ARLINGTON COUNTY, VIRGINIA

**County Board Agenda Item
Meeting of May 22, 2010**

SUBJECT: SP# 395 Site Plan Amendment to modify density, parking, height, facades, landscaping, utility locations, located at 3565 Lee Hwy.

LOWER GARAGE REVISED

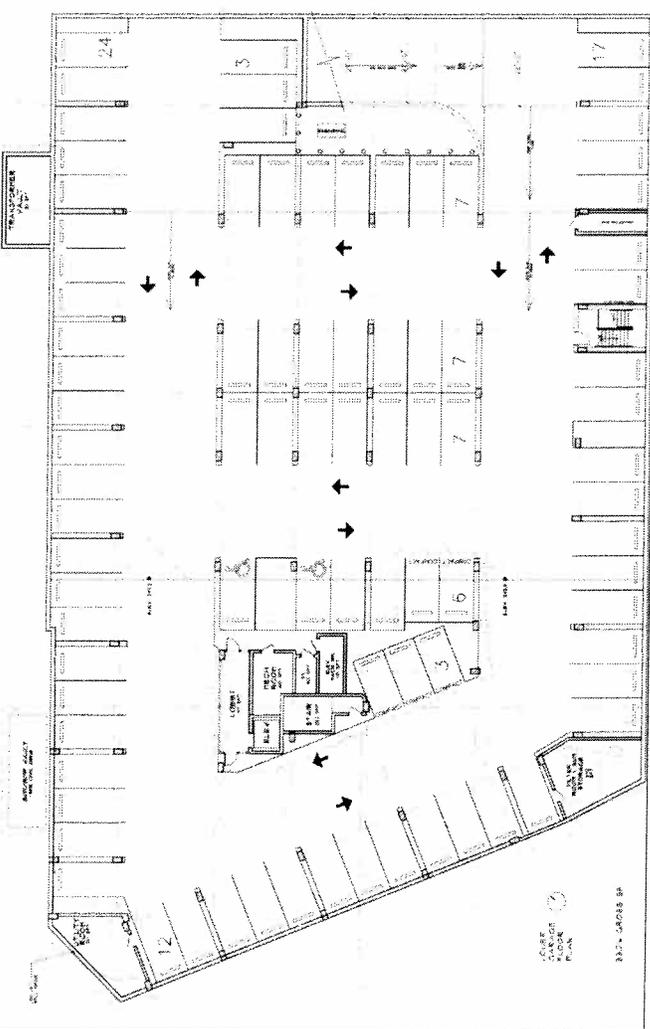
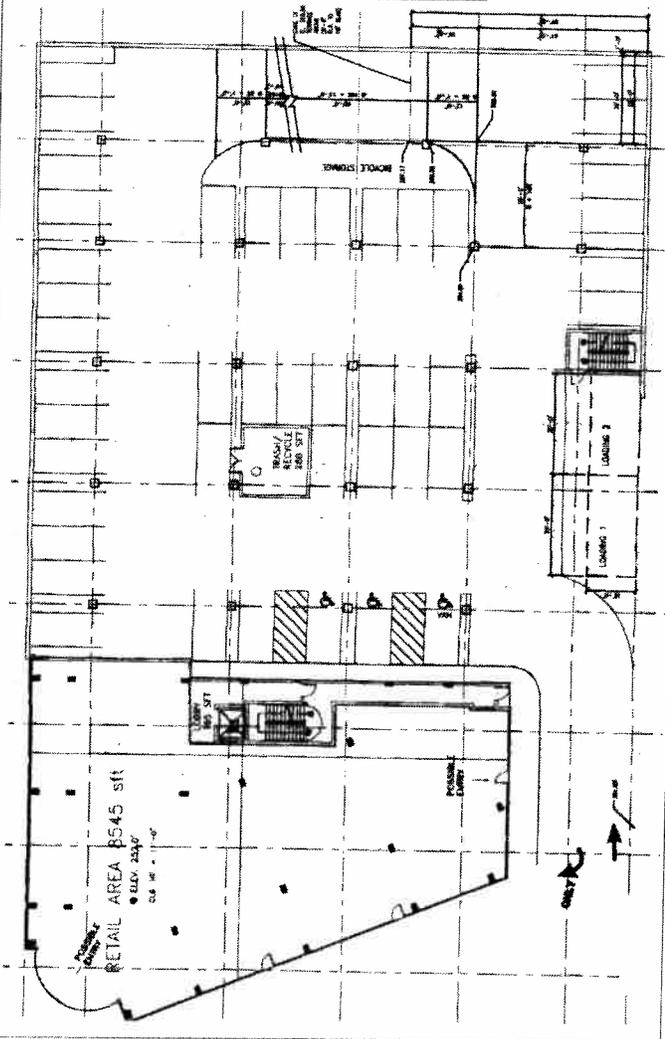
Parking: The 2005 approved plan provided a parking garage with ingress/egress from Lee Highway and Monroe Street for 49 residential units with 88 residential parking spaces (1.80 spaces/unit), in addition to 9,777 square feet of retail and 1,232 square feet of commercial/office space with 39 retail spaces (1 space/251 s.f.). The proposed plan provides 66 residential units with 93 residential parking spaces (1.4 spaces/unit) and 9,221 total square feet of retail and commercial/office with 37 retail spaces (1 space/249 s.f.). Both of these ratios substantially exceed site plan standards for parking, which was a significant concern to the neighborhood. Staff supports these ratios.

We have also previously expressed our concern that the number of parking spaces in the TV Station property's garage will not adequately serve the proposed increased number of rental units. While we acknowledge that the revised ratio of parking to units exceeds minimum county requirements, we encourage the Planning Commission and the County Board to give careful consideration to the particular circumstances of the Maywood neighborhood. The existing apartment complexes on North Monroe Street already utilize North 21st Avenue as an overflow parking lot on evenings and weekends. Without addressing that problem, the new development will further exacerbate an already strained situation.

SOUTH ELEVATION APPROVED

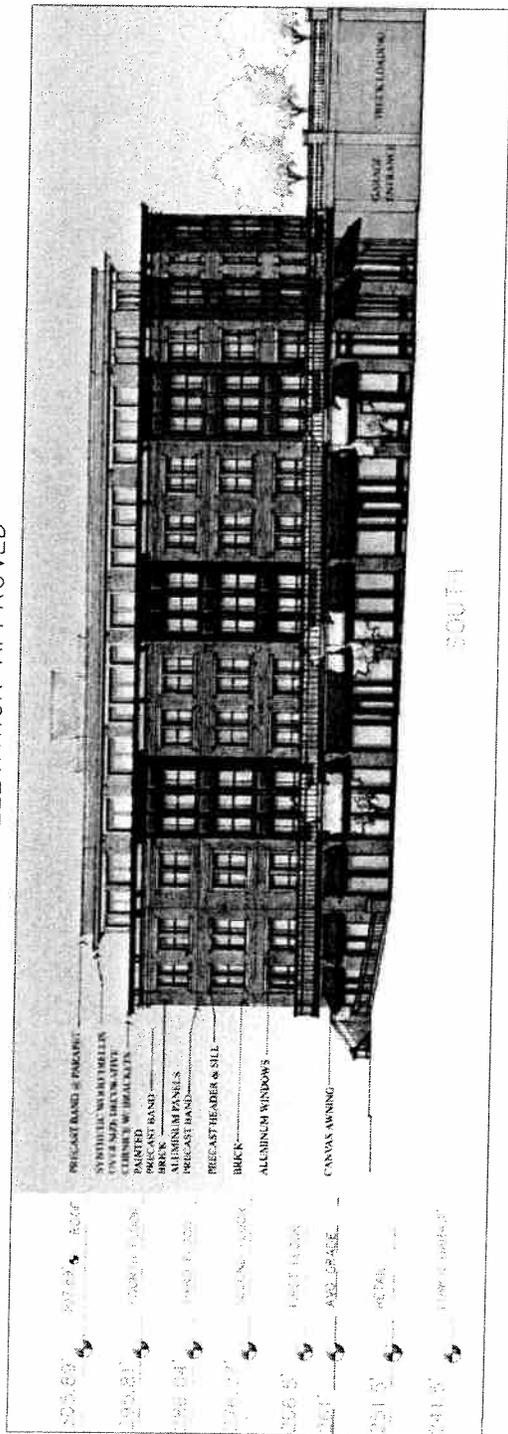
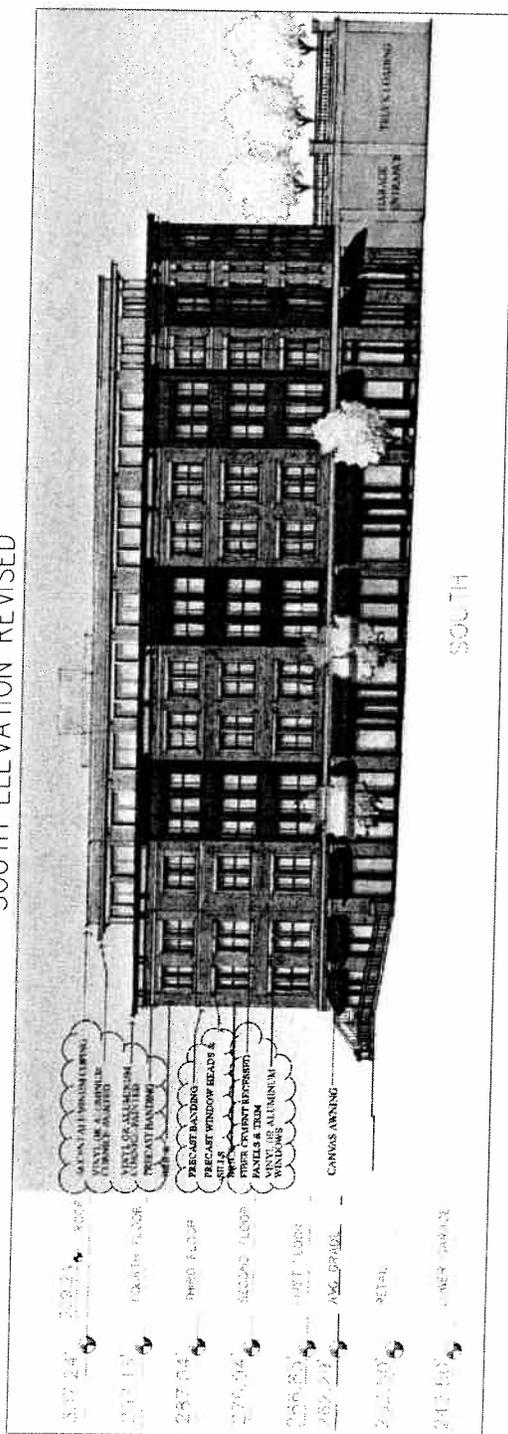
Planning staff, Historic Preservation staff, the community, the Site Plan Review Committee, and the Historical Affairs and Landmark Review Board (HALRB) chair reviewed the requests for revisions to several of the trim materials. The final consensus was that all of the proposed revisions were appropriate for the location and building, and would not detract from the building quality, except for a proposal to revise precast banding and window heads and sills to brick. The applicant has agreed to retain precast in these locations. Staff supports the current proposed materials.

- Change in the trim materials, from precast to brick on cornices and accent bands - which we have objected to;
- Change to from aluminum parapets to compressed PVC or hardiplank for the window bays were OK as long as they have the dimensionality of original drawings which looked like 1 inch wide trim pieces making squares, adding interest;
